RECORD DRAWING REVISIONS

TOWN OF SHELBURNE
SEWER/WATER RELOCATION (AOT WORK)
PLAN AND PROFILE
STA. 309+00 TO 315+00

Shelburne NH EGC 019-4 (27)
Sheet 473 of 537

SHEET **C-13**

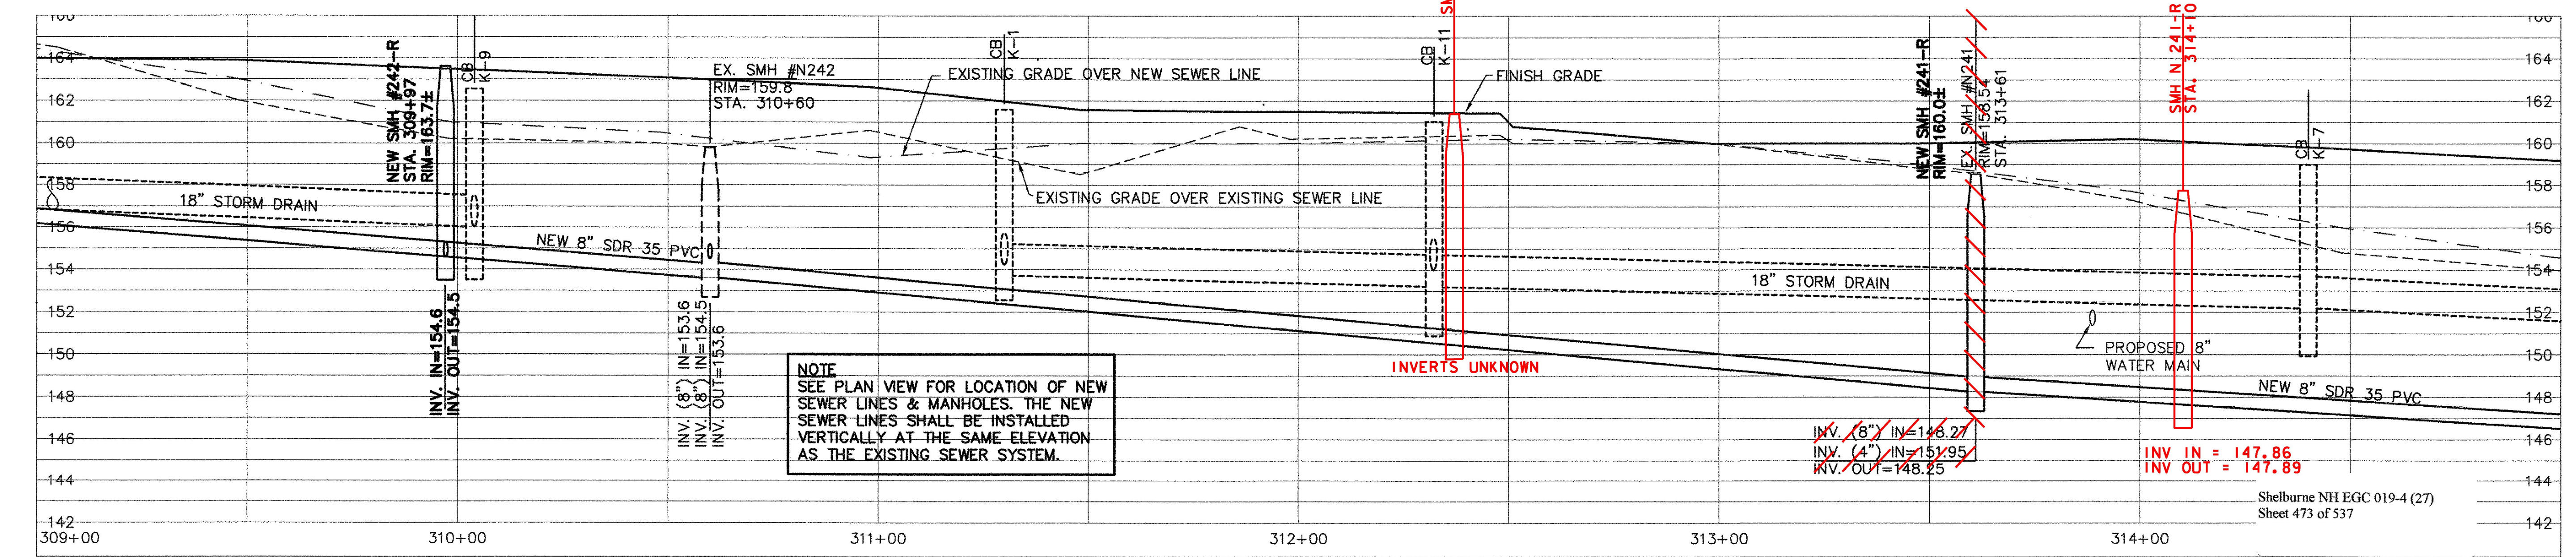
NO.	DATE	DESCRIPTION
1.	11/10/09	FIELD MARK UPS ADDED TO THE PLANS
